### Amendments to the Drawings

Marked up drawing  
Serial No. 09/709,237

# LIFESPAN OF FAST CLOTTING THROMBIN FRACTIONATED AT DIFFERENT ETOH CONCENTRATIONS

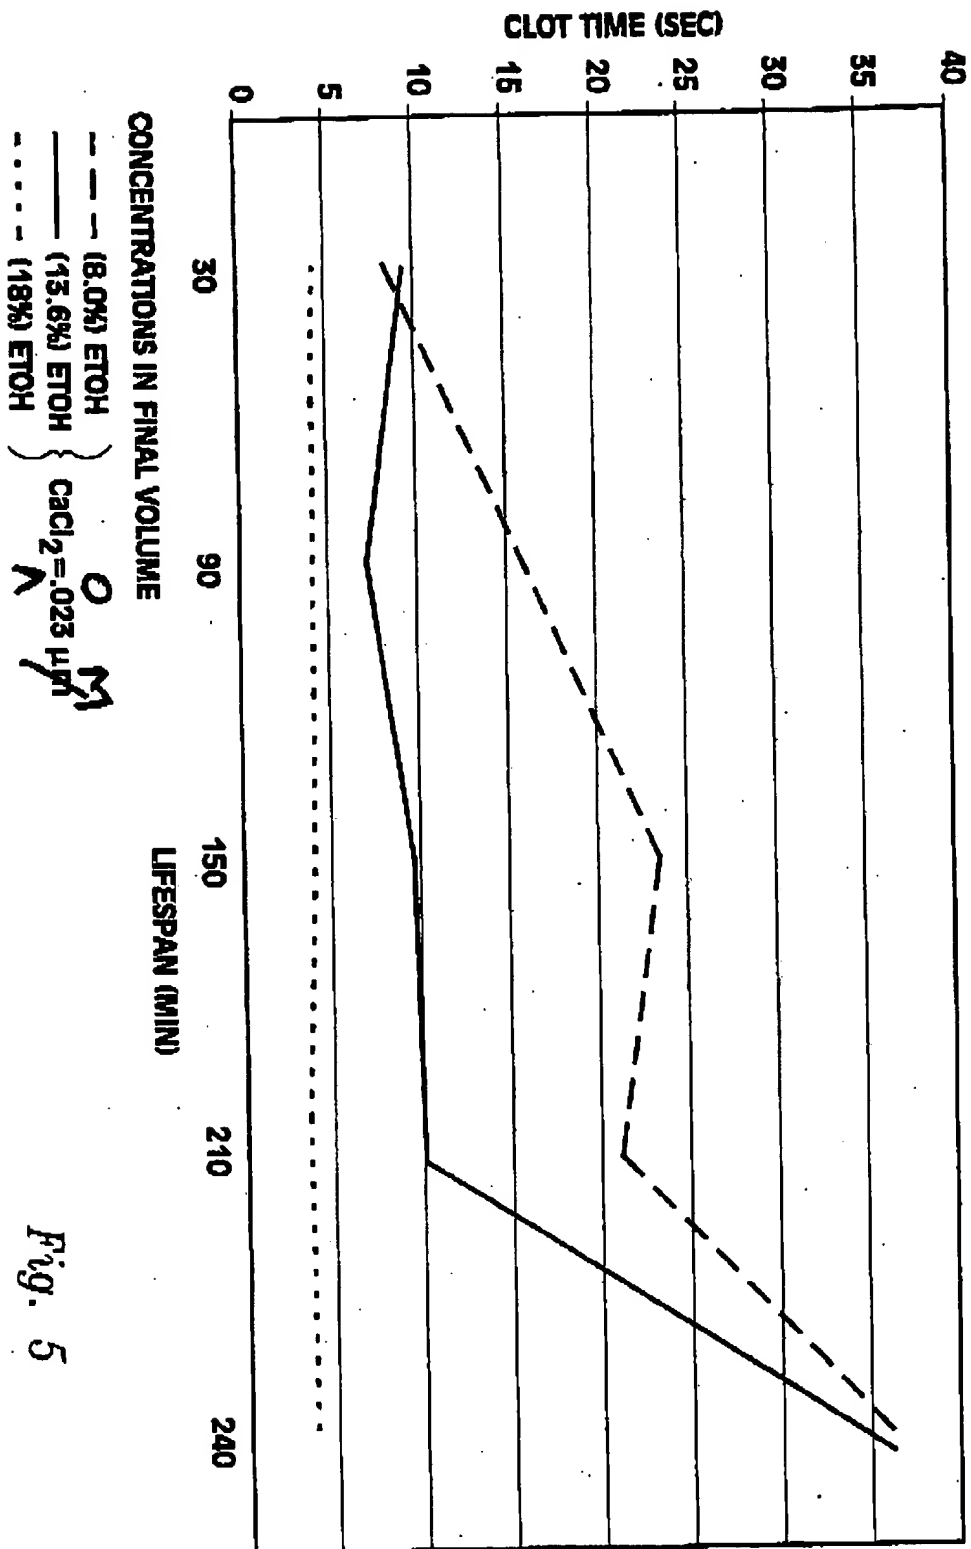
Figs 5 and 6 have been corrected in response to the Examiner's objections, to show the proper abbreviation for micromolar. Figs. 5 and 6 now read " $\mu\text{M}$ " instead of "mM."

Applicants have also amended Figs. 5, 6, 7, 8, 9, 10, and 11 to refer to "0.023", "0.011", and "0.045" instead of "023", ".011", and ".045", respectively to add a "0" in the ones column for clarity and ease of reading.

The Examiner has objected to Figs. 5 and 6 on the grounds that they refer to the concentration of calcium chloride in units of " $\mu\text{m}$ " which is an incorrect abbreviation for micromolar ( $\mu\text{M}$ ). (Office Action, page 3, paragraph 6). Applicants appreciate the Examiner's notation of this error. Applicants have corrected Figs. 5 and 6 to read " $\mu\text{M}$ "

Fig. 7

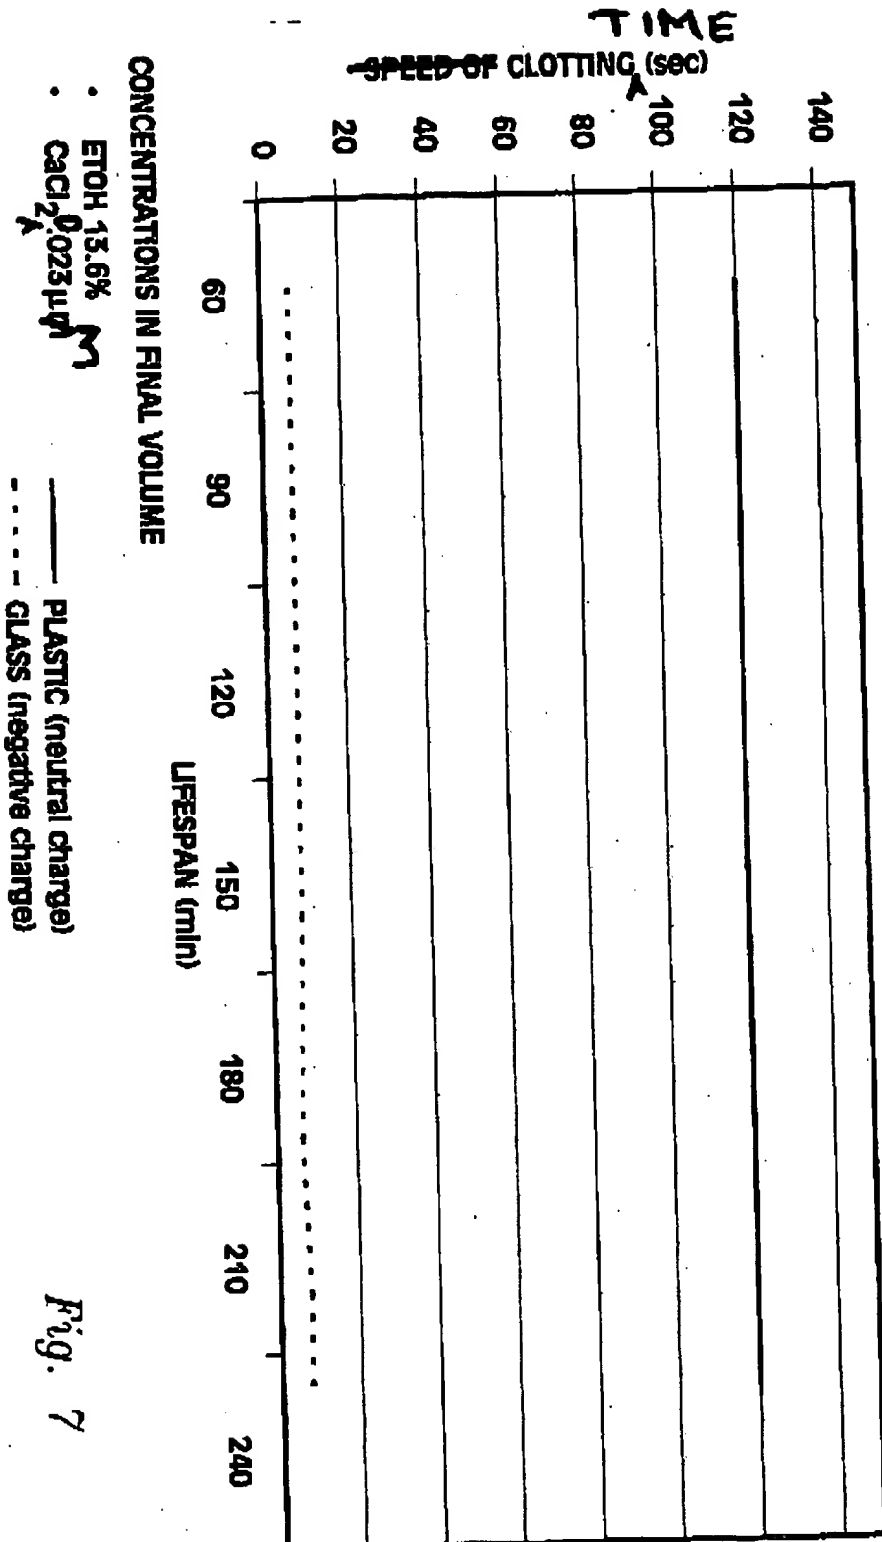
In addition, applicants have corrected Figs. 7, 8, 9, 10, & 11, which also contain the same error. These figures now read " $\mu\text{M}$ " instead of "mM."

Applicants have amended the title of Fig. 7 to change "clotting speed" to "clotting time." Fig. 12 has also been amended to add a label to the Y axis of "Clotting Time (Sec)", which was inadvertently omitted in the submission of formal drawings.

In addition, applicants have corrected the title of Fig. 7 to change "clotting speed" to "clotting time" and Fig. 12 to add a label to the Y axis of "Clotting Time (Sec)". The omission of the label on the Y axis of Fig. 12 was an inadvertent omission in the submission of formal drawings, as Fig. 12 as originally submitted included this label.
